DRESDEN NUCLEAR POWER STATION, UNIT 2

AMENDMENT TO PROVISIONAL OPERATING LICENSE

Amendment No. 75
License No. DPR-19

ATTACHMENT TO LICENSE AMENDMENT NO. 75

Figure 3.5-1
(Sheet 2 of 5)

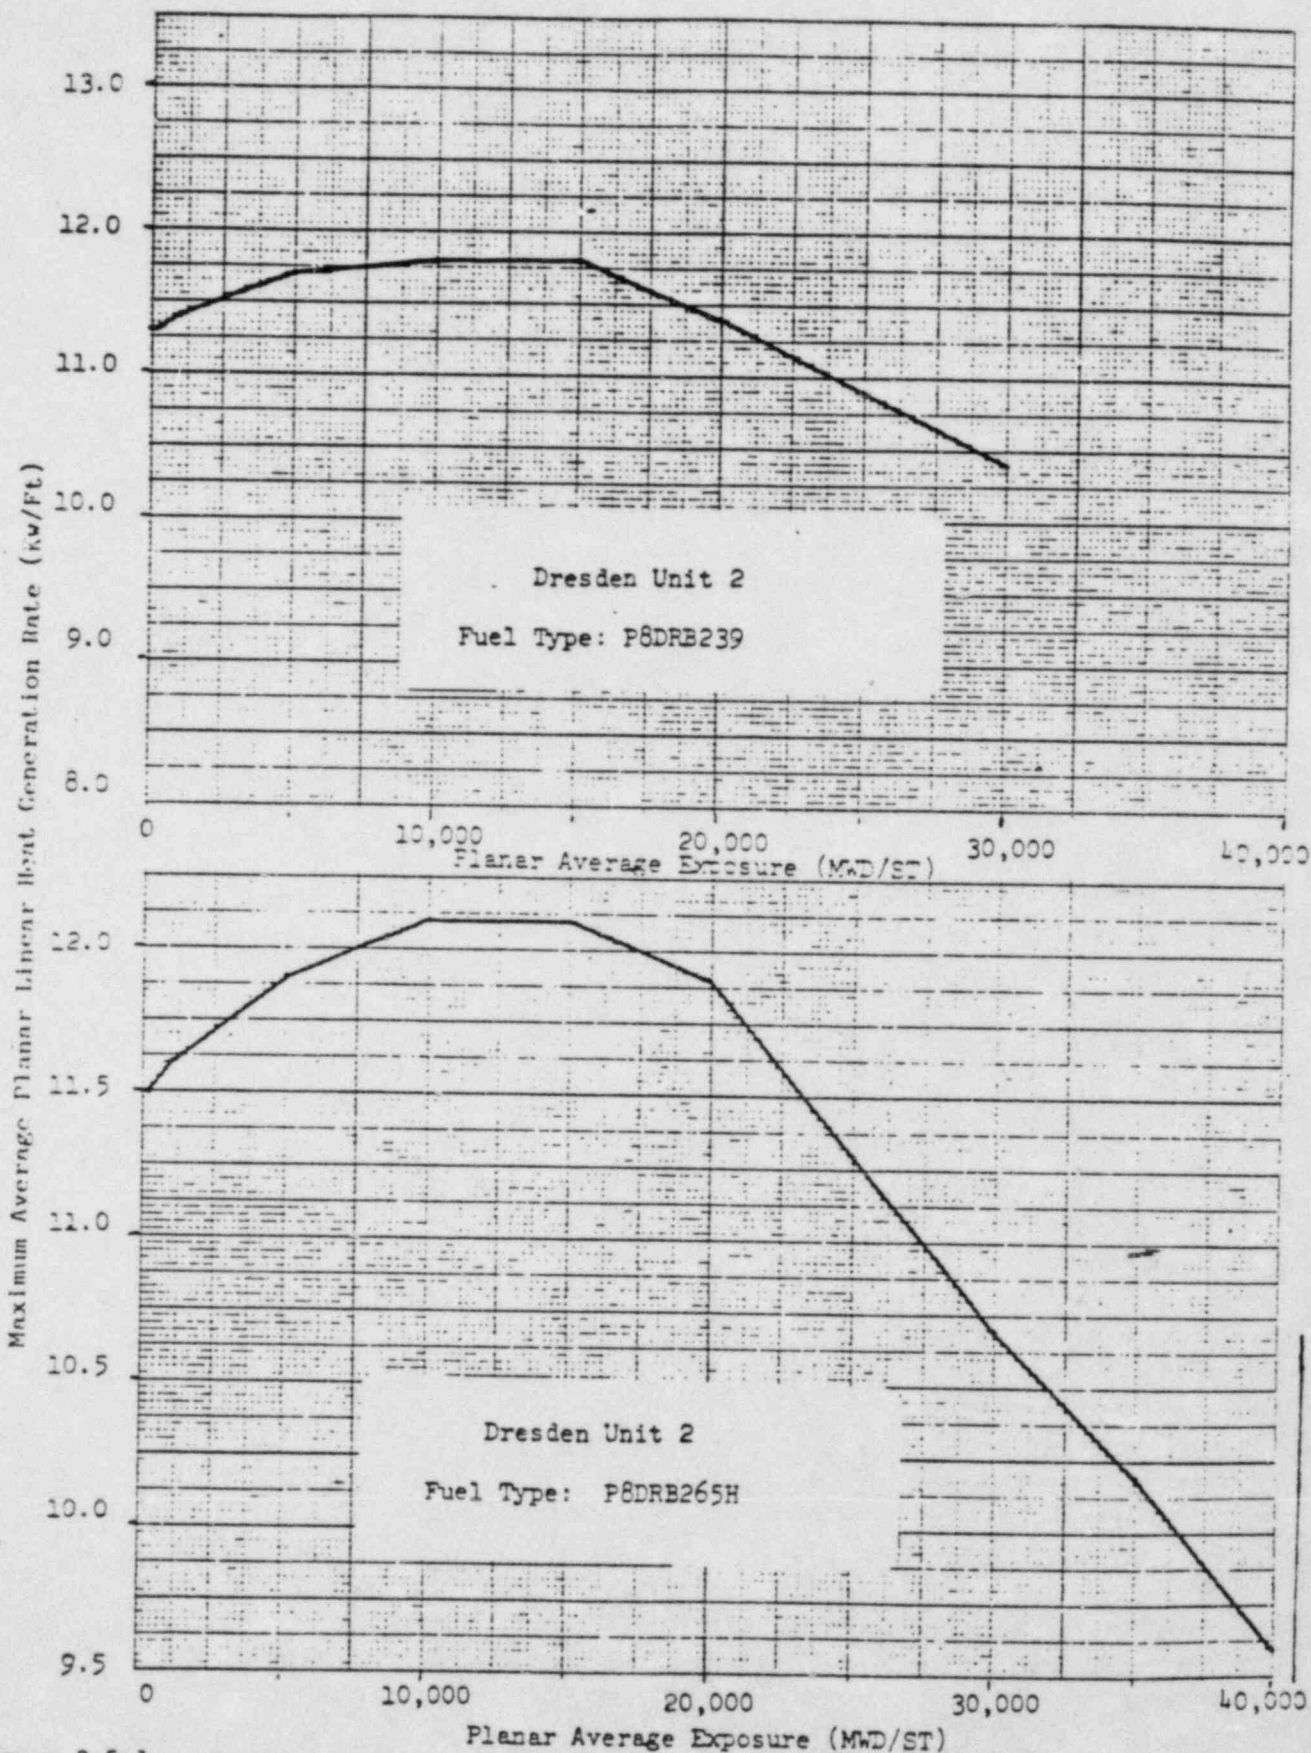
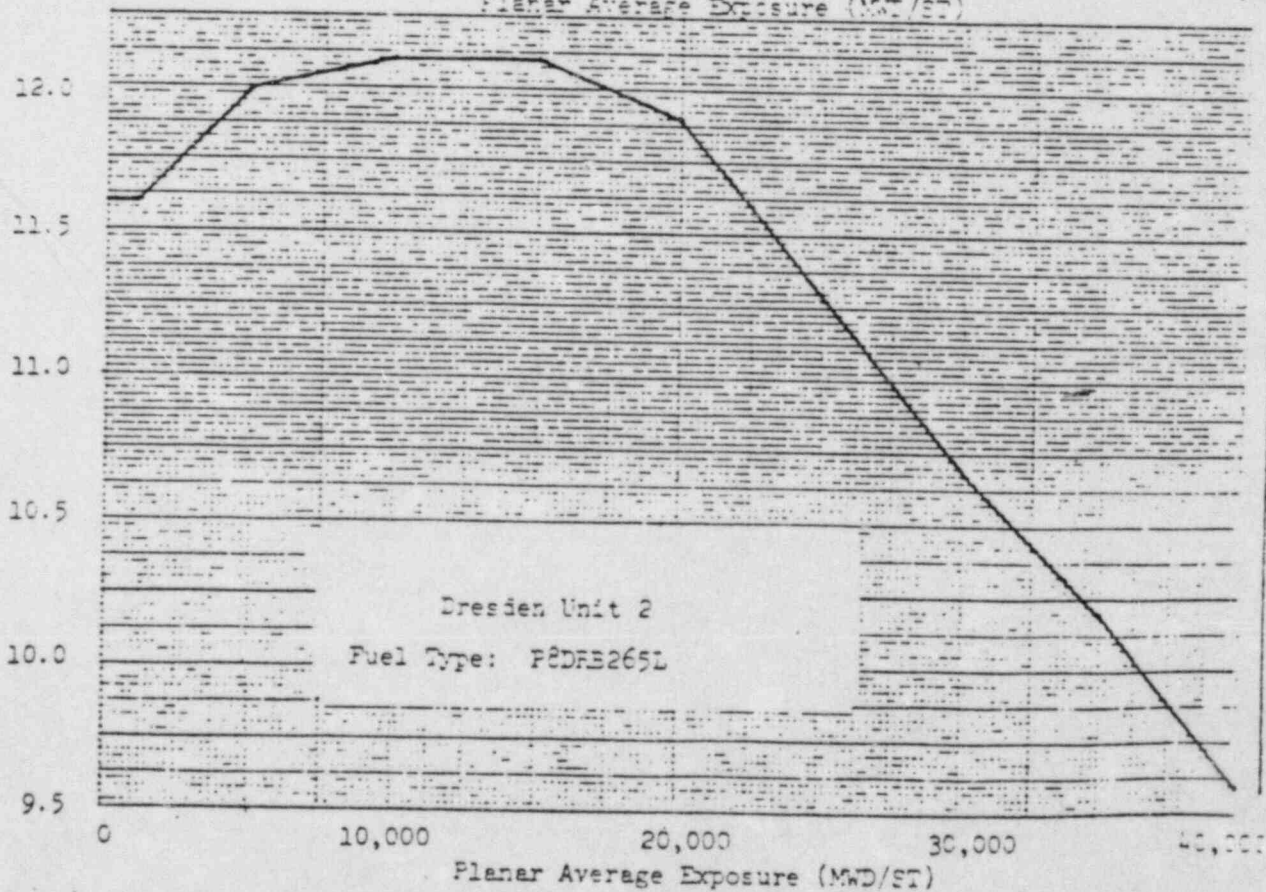
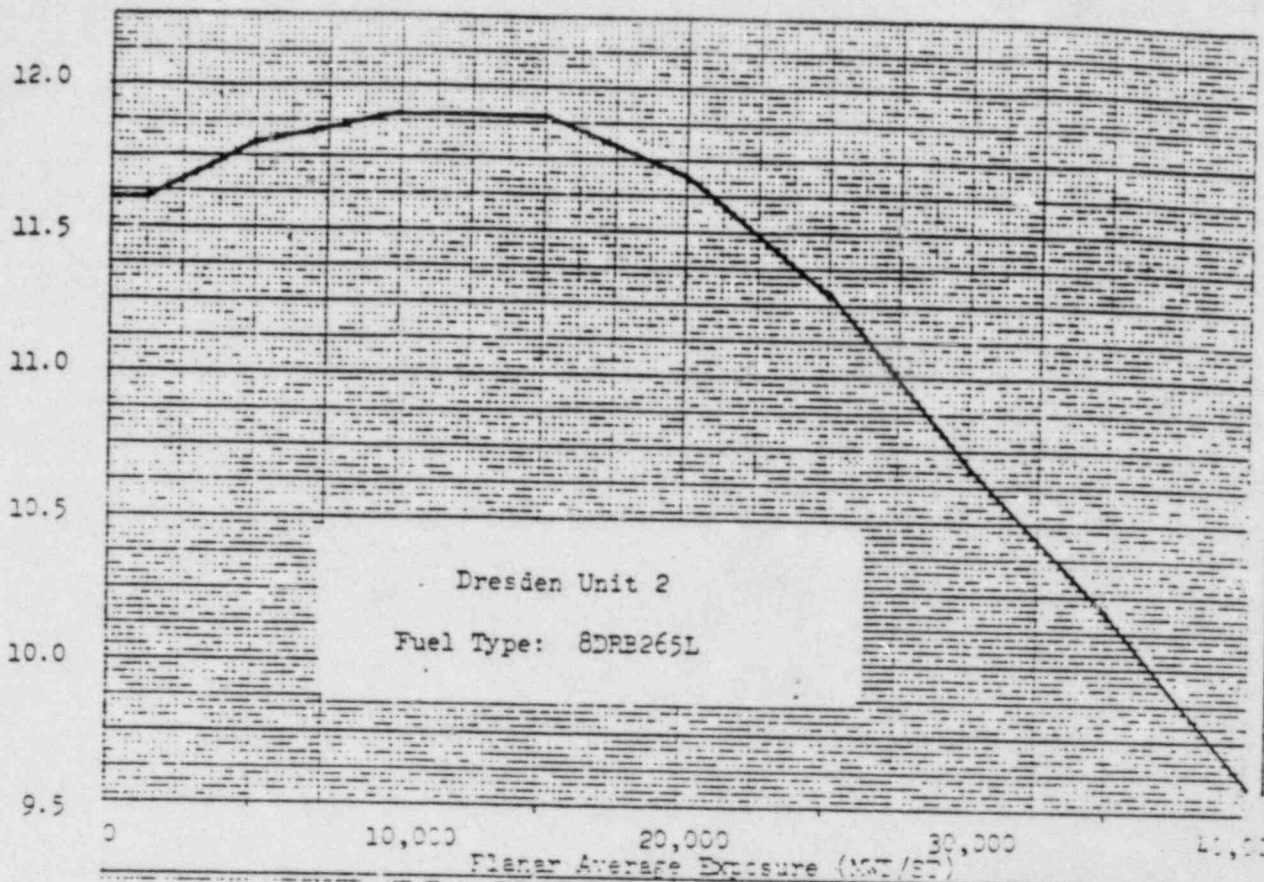
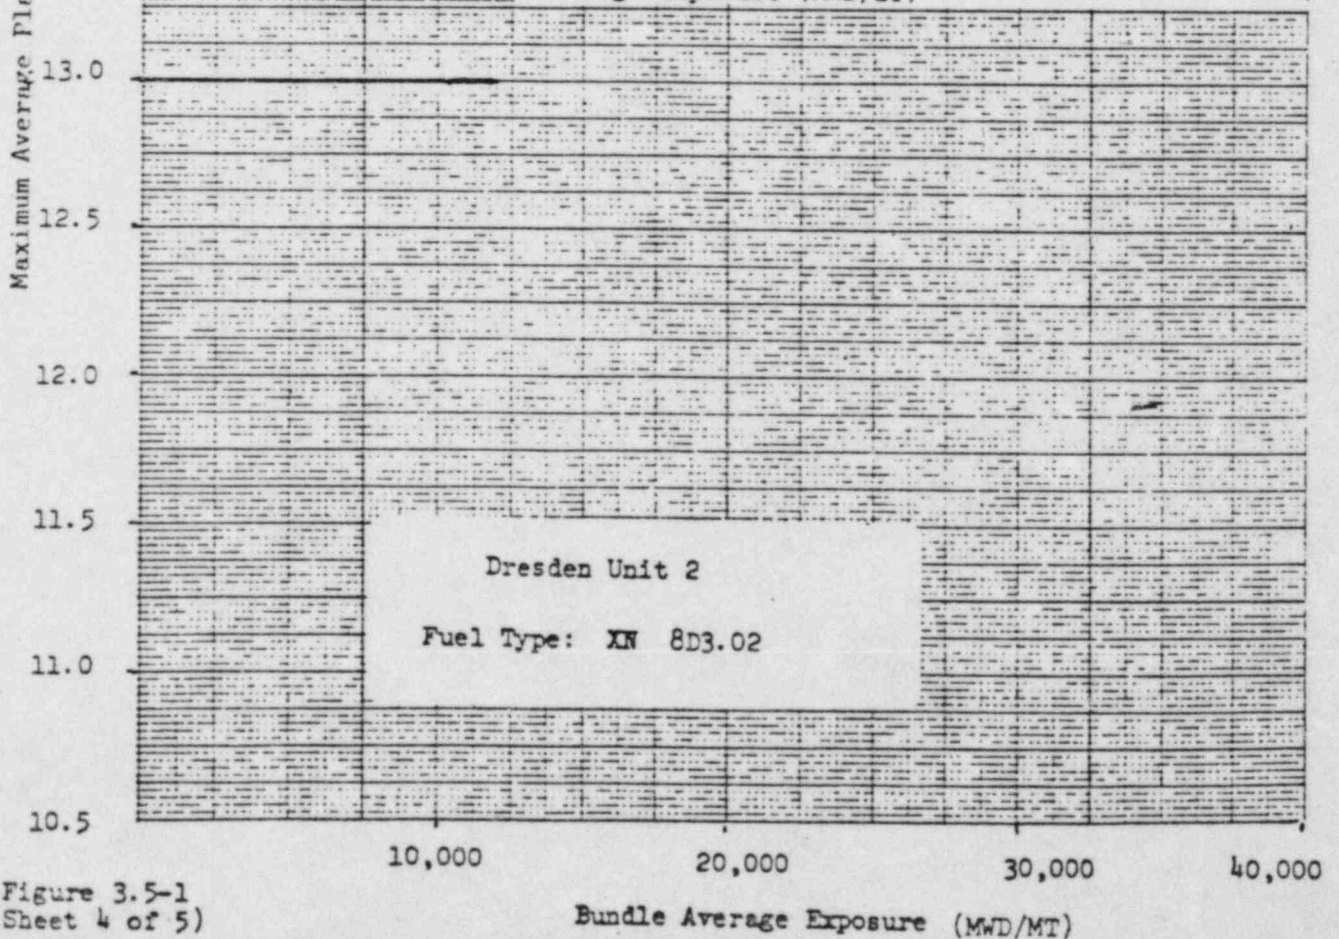
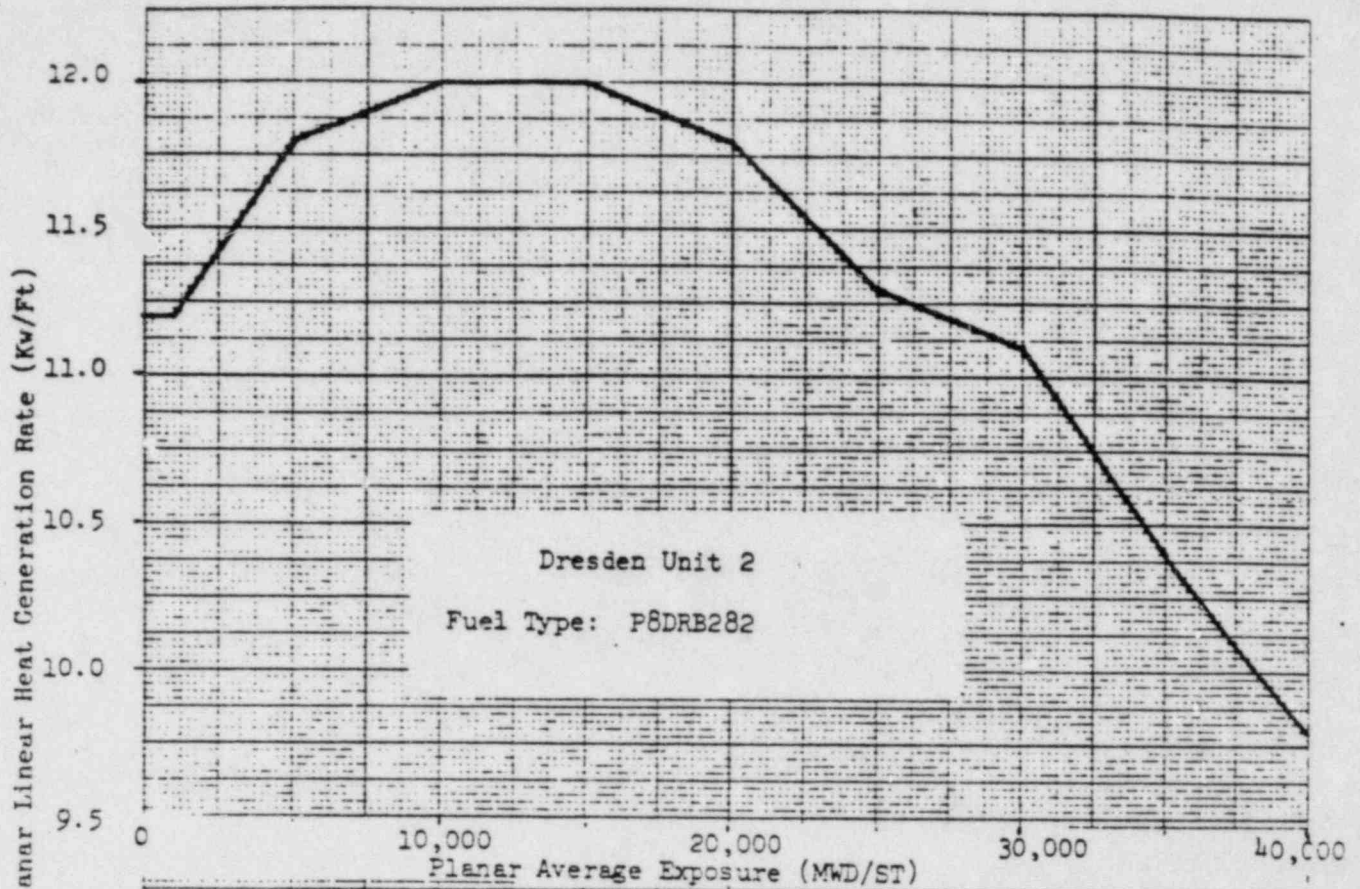
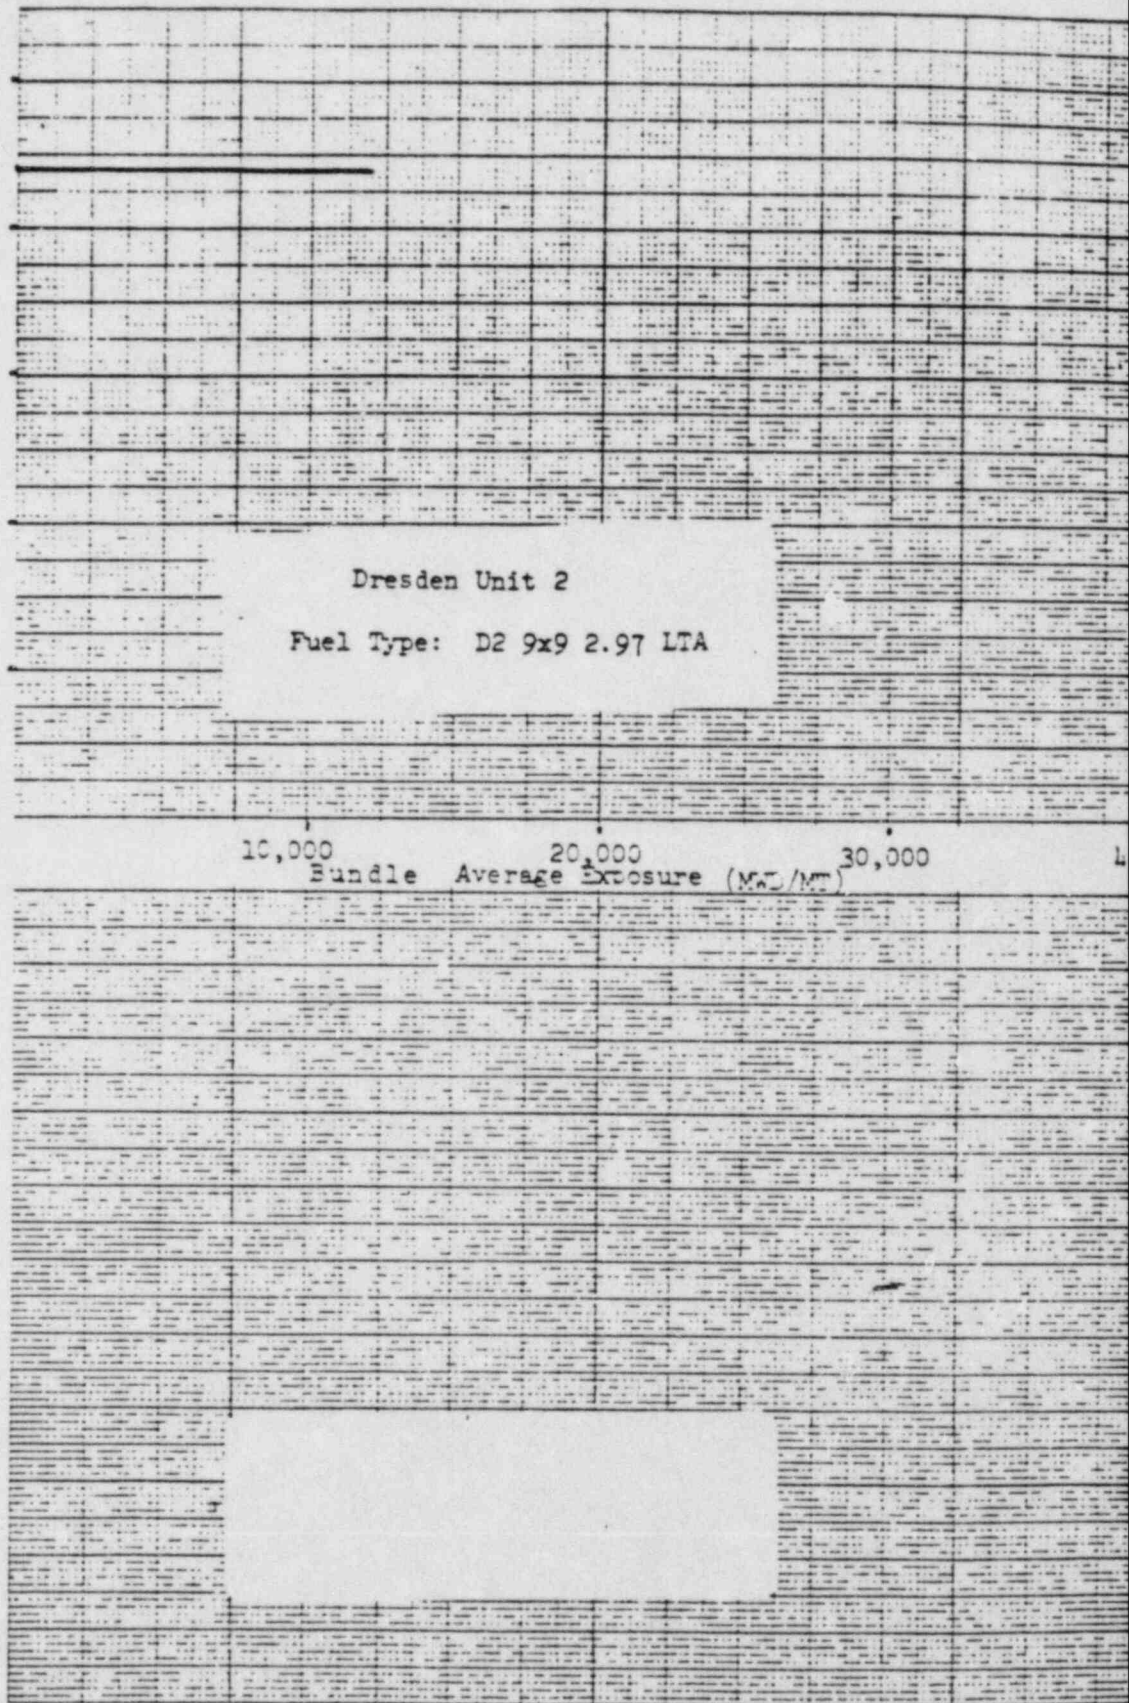
- 3.M.2 The Minimum Critical Power Ratio (MCPR) Safety Limit will be increased 0.03 (TS 1.1.A and 3.3.B.5.C)
- 3.M.3 The MCPR Limiting Condition for Operation (LCO) will be increased 0.03 (TS 3.5.K and Fig. 3.5-2)
- 3.M.4 The Maximum Average Planar Linear Heat Generation Rate (MAPLHGR) limits will be reduced to 70% of current values for all fuel types.

(TS reference 3.5.I)

any axial location, shall not exceed the maximum average planar LHGR shown in Figure 3.5-1. If at any time during operation it is determined by normal surveillance that the limiting value for APLHGR is being exceeded, action shall be initiated within 15 minutes to restore operation to within the prescribed limits. If the APLHGR is not returned to within the prescribed limits within two (2) hours, the reactor shall be brought to the Cold Shutdown condition within 36 hours. Surveillance and corresponding action shall continue until reactor operation is within the prescribed limits.
